**VENTURA UNIFIED SCHOOL DISTRICT
ELMHURST ELEMENTARY SCHOOL HVAC REPLACEMENT**

ADDENDUM #01

ADDENDUM NUMBER ONE

**E1-24 ELMHURST HVAC**

1 REFLECTED CEILING PLAN - BLDG. A
SCALE : 1/8" = 1'-0"

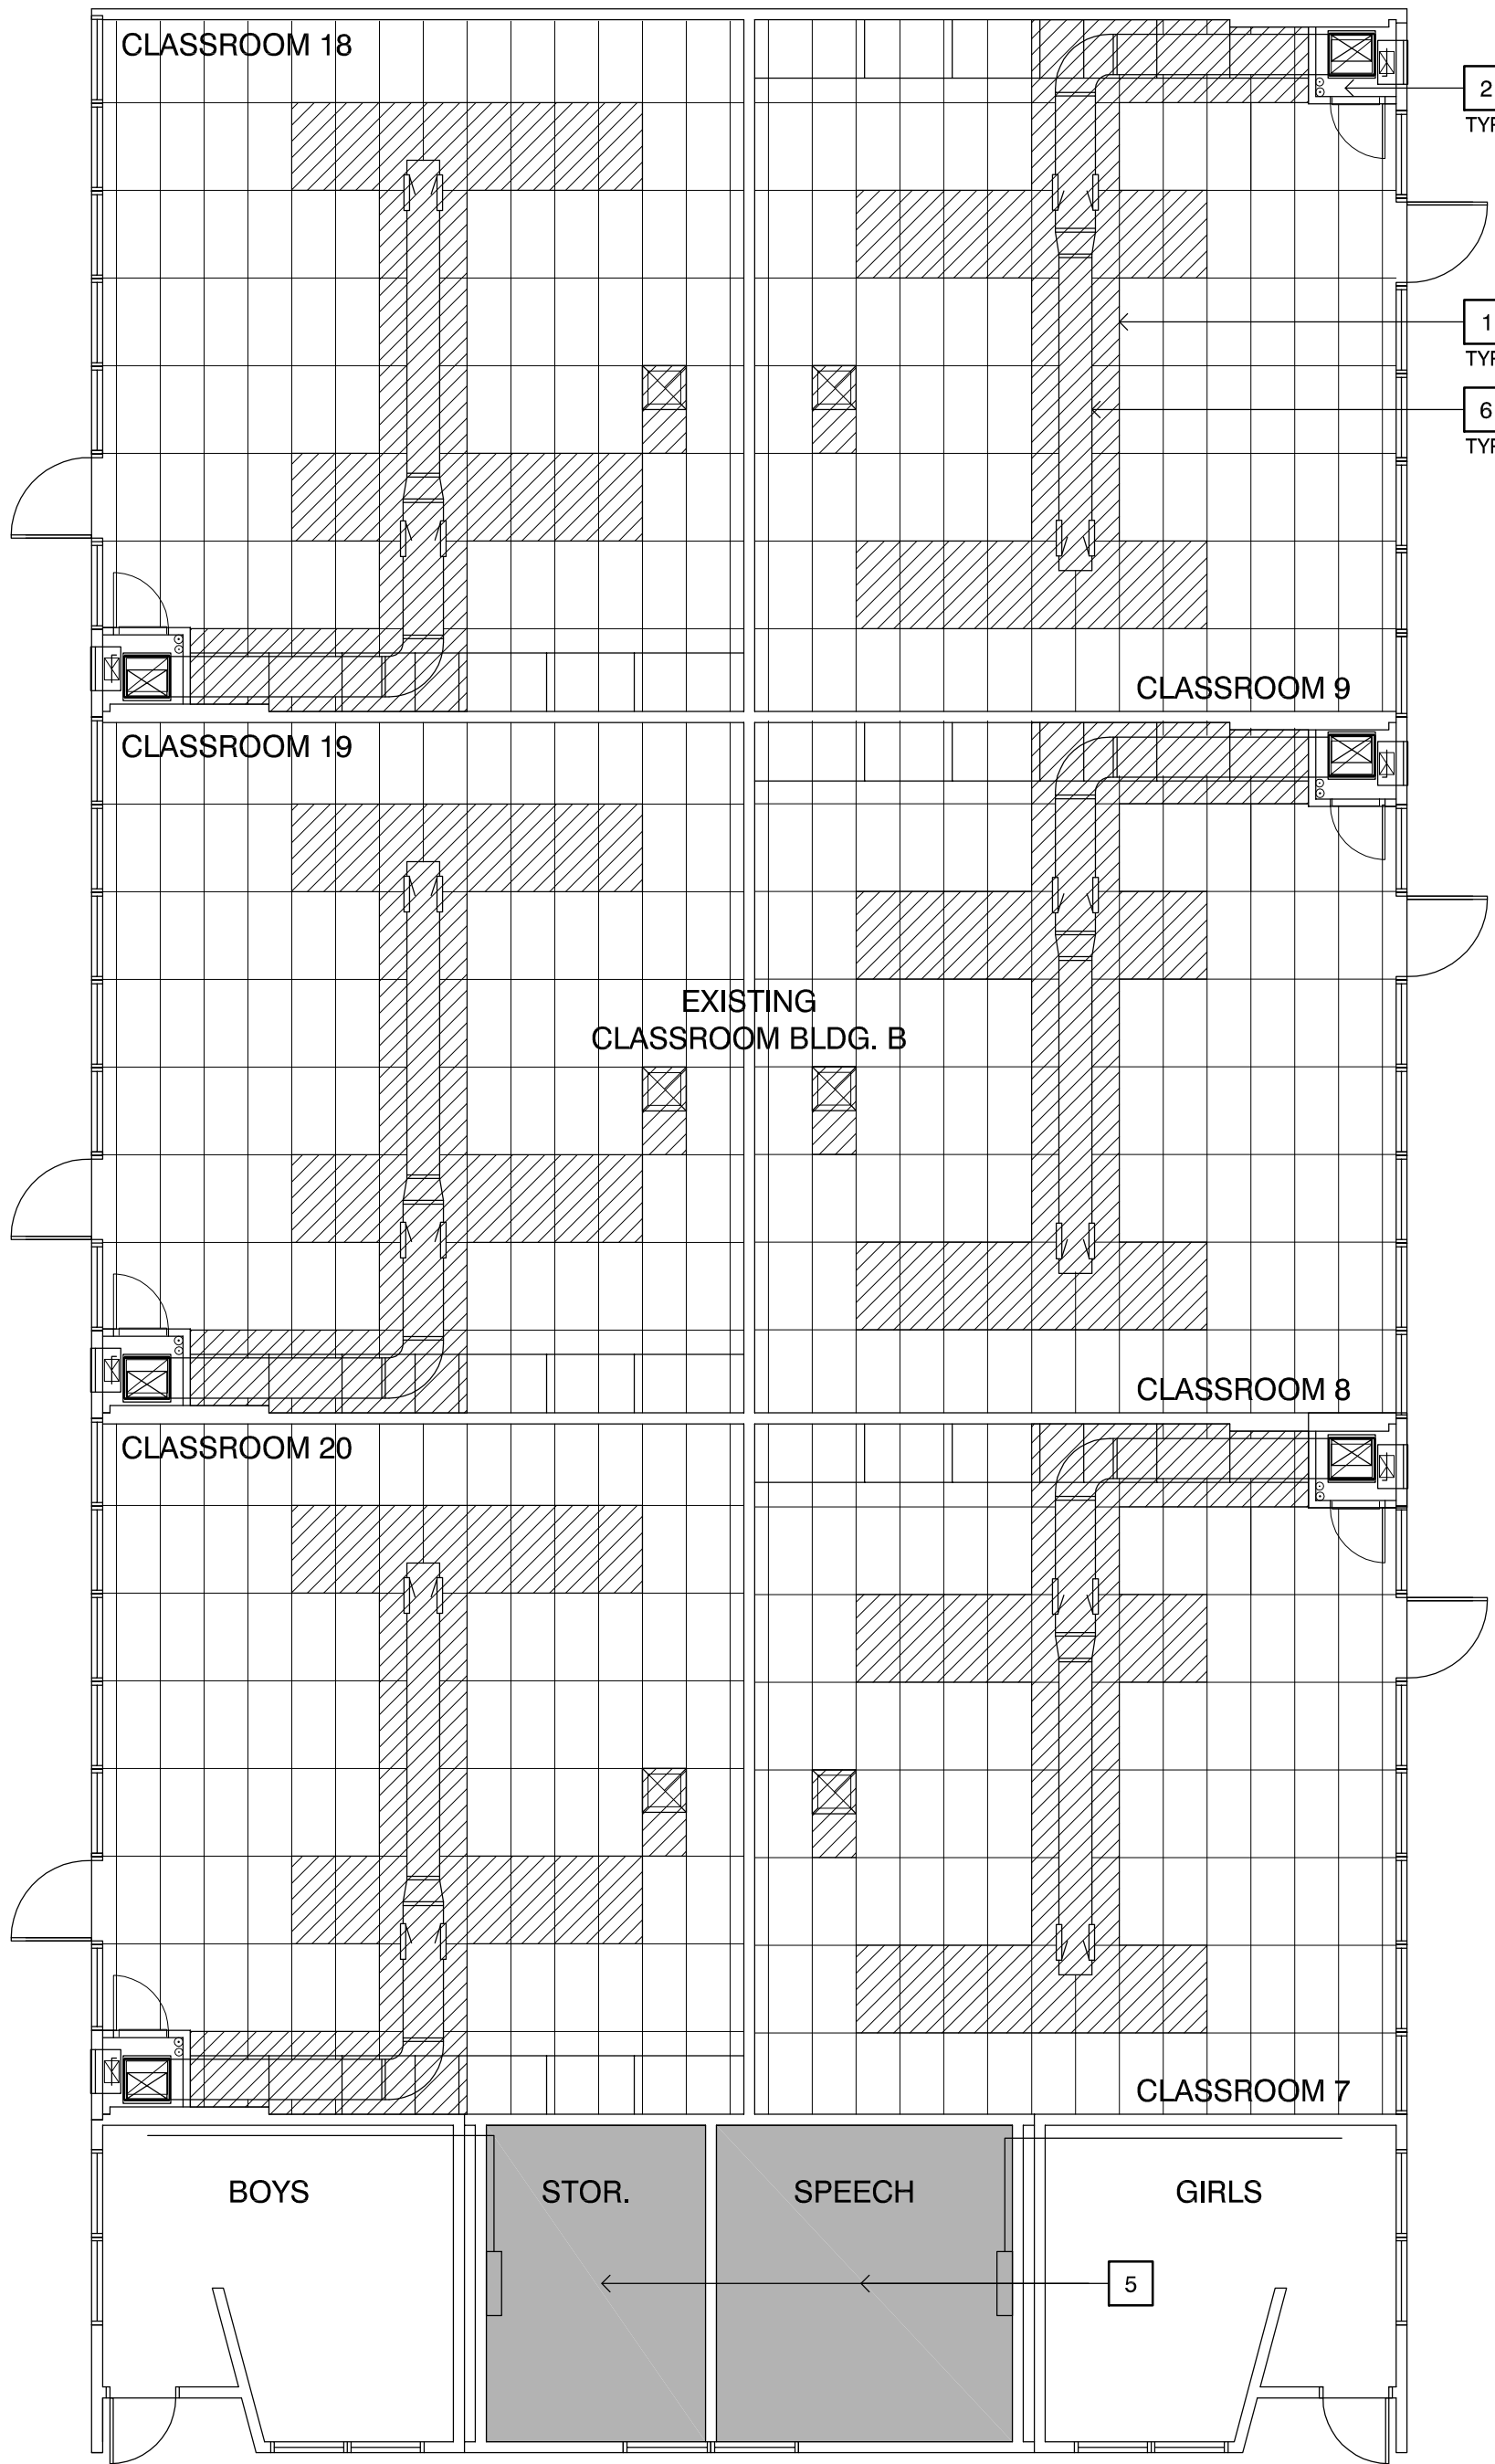
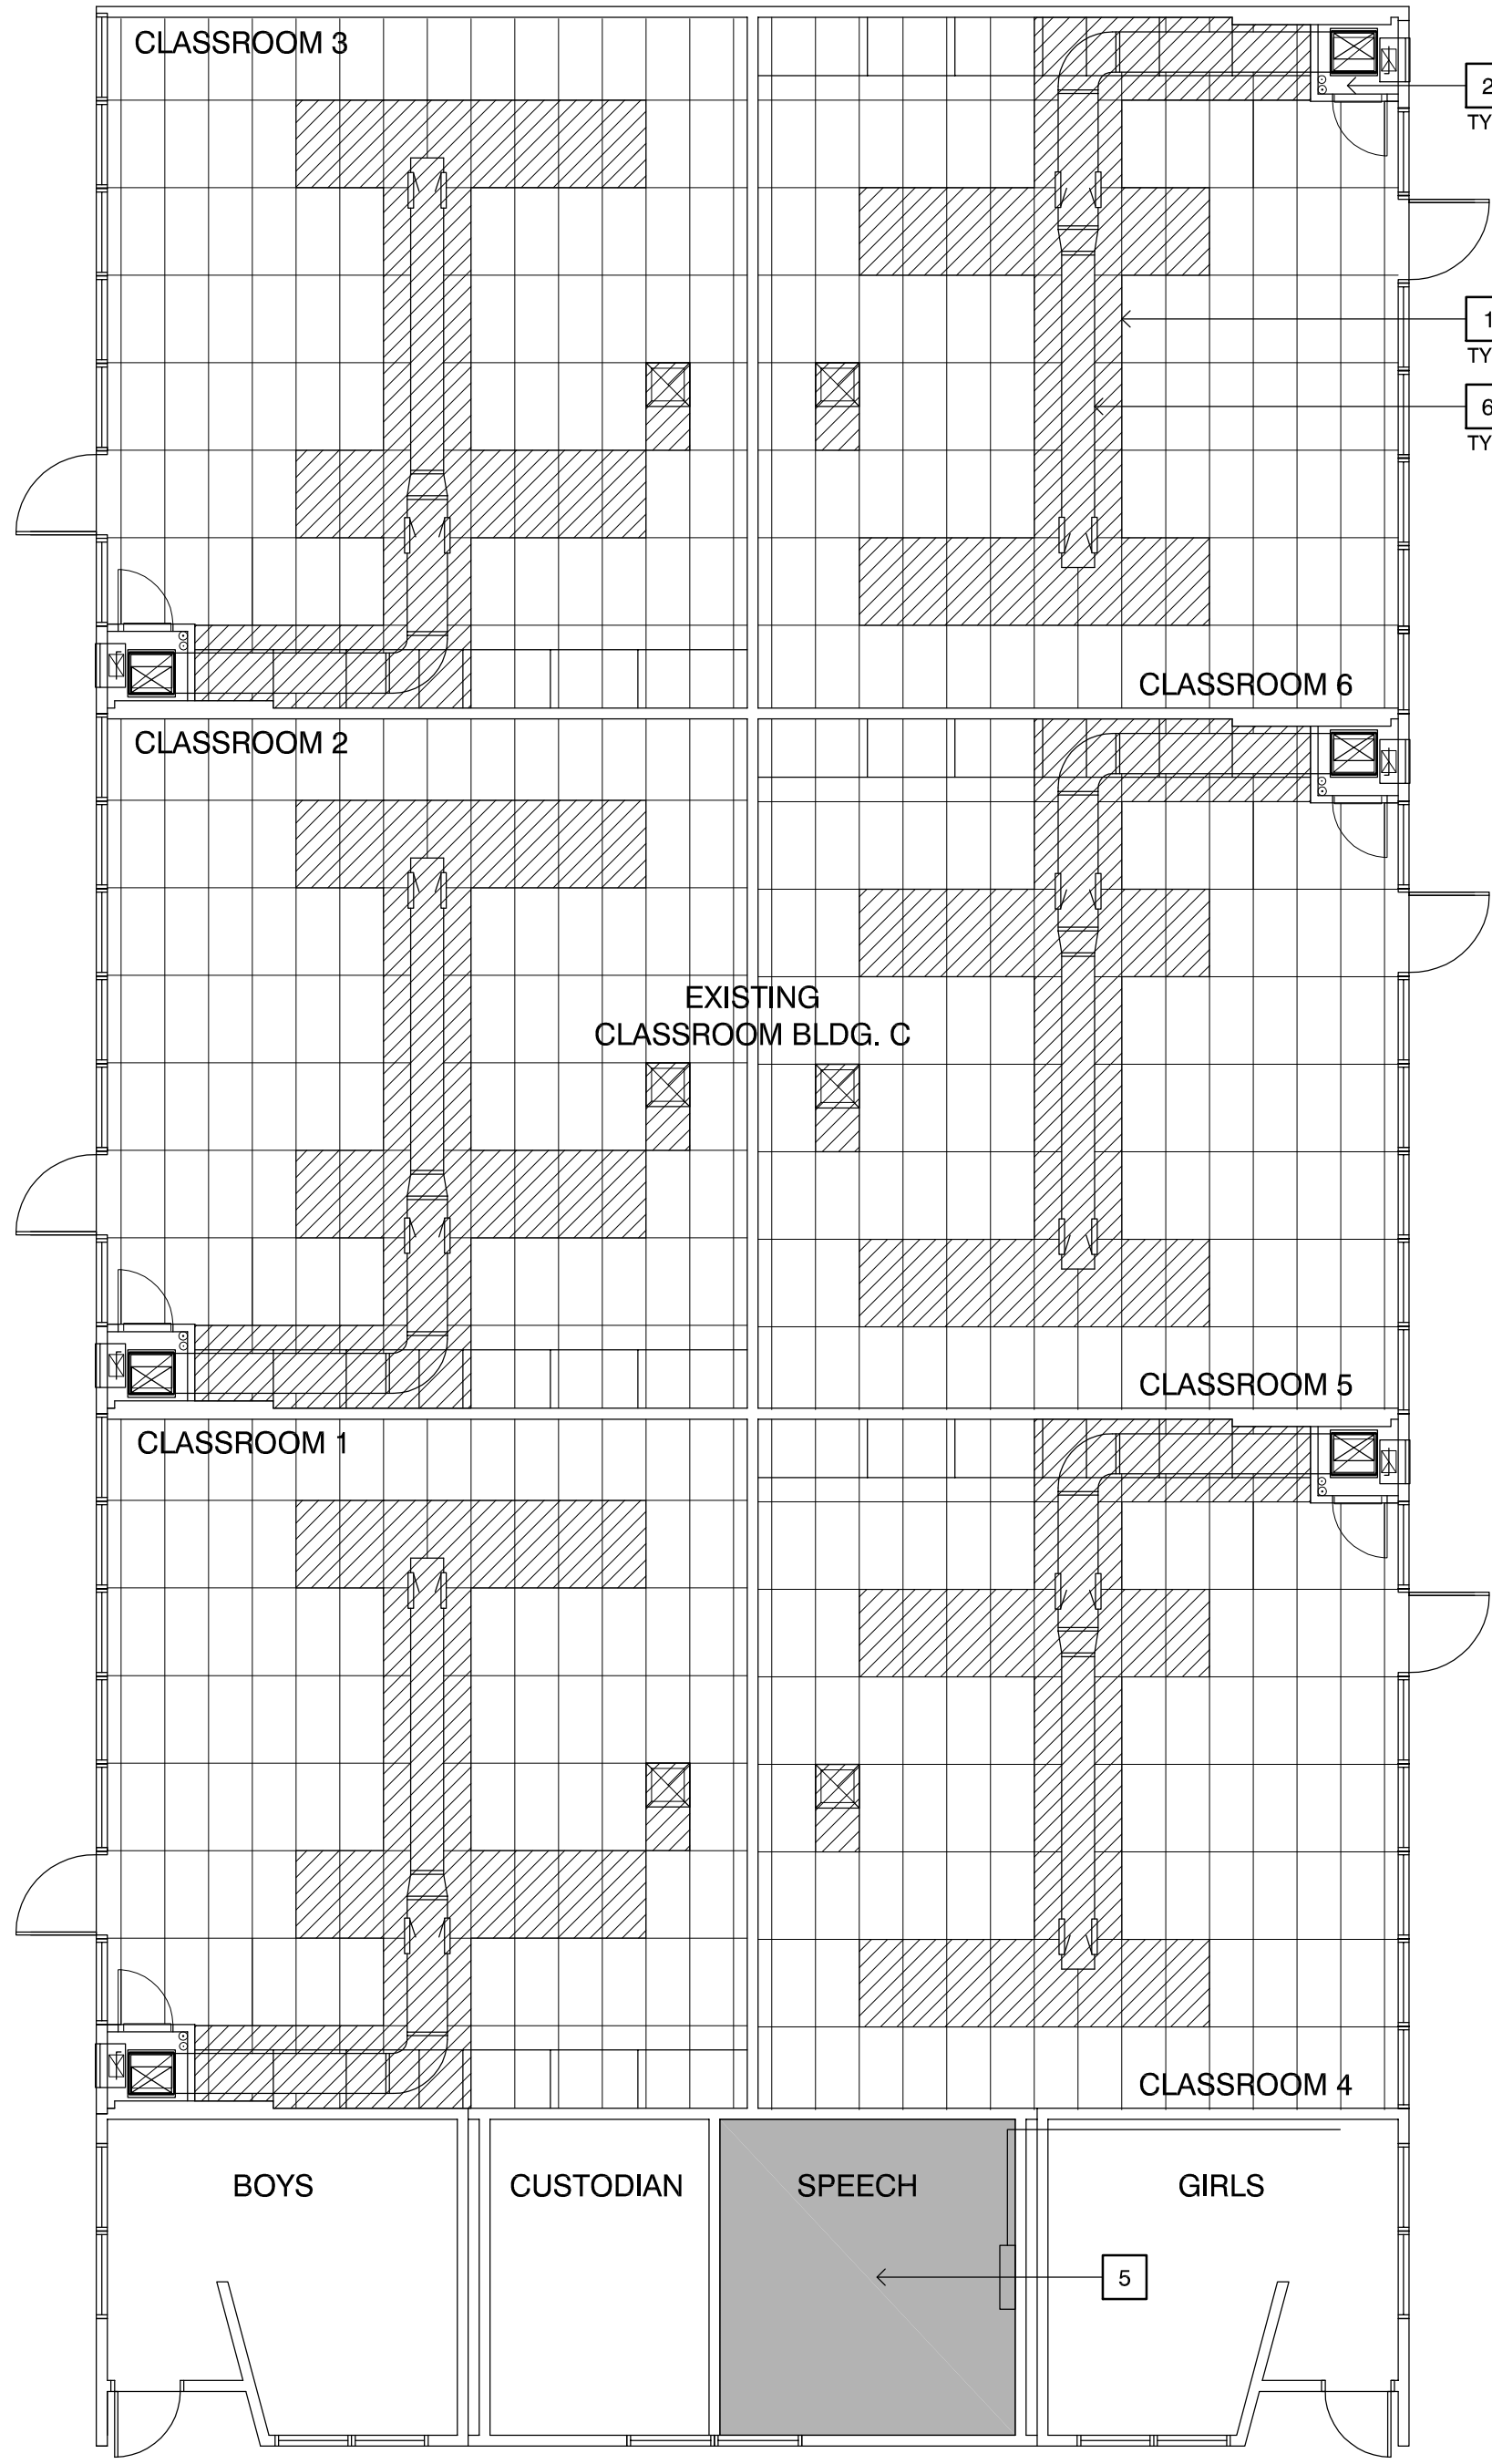
Insert two new drawing sheets A-600 and A-601 to the bid plans. These new reflected ceiling plans indicate extent of planned ceiling modifications and replacements.
